Fair Oaks Boulevard Complete Streets Project

Meeting Summary

Thursday, September 15, 2016

Concept 1:

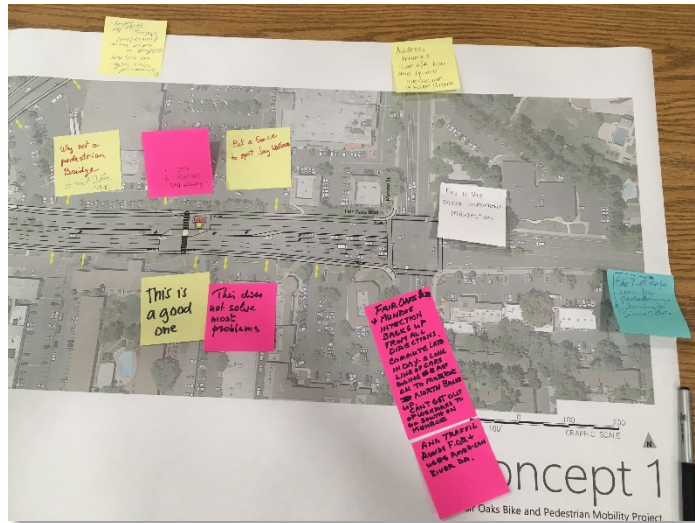
- [Between Howe Avenue and University Avenue] Crosswalk here for peds.
- [Fair Oaks Boulevard / University Avenue] Ped control here
- [Fair Oaks Boulevard / University Avenue] Ped crossing / bike needed at University Avenue!
- [Eastbound frontage road entrance across from Pavilions] How do I get across here? Driving
- Bridge increase commerce quality on south side
- Why not a pedestrian bridge?
 - Great idea
- [Fair Oaks Boulevard / Fulton Avenue] Ped control here
- [Fair Oaks Boulevard / Fulton Avenue] Replace mature shade trees any removed
- Not safe even for pedestrians returning to Sierra Oaks

- I see most people here
- Bridge – lots of Kaiser lunch hour crossing

- Pedestrian overcrossing?

- This is a good one!
- Off-set crosswalk?
- Only 2, don't need this one

- This is a good one
- This does not solve most problems
- Put a fence to [stop] jay walking
- I support this crossing here
- Commercial truck traffic especially early AM
- Difficult to pull out because of visibility / ped

- Fair Oaks Blvd + Munroe intersection backs up from all directions. Commute late in day – a long line of cars going East onto Munroe north backs up. Can't get out of Loehman's to go South on Munroe and traffic avoids FOB and uses American River Drive.
- This is the most important intersection.
- Address triangle: lop off bar and square intersection at Fulton/Sierra
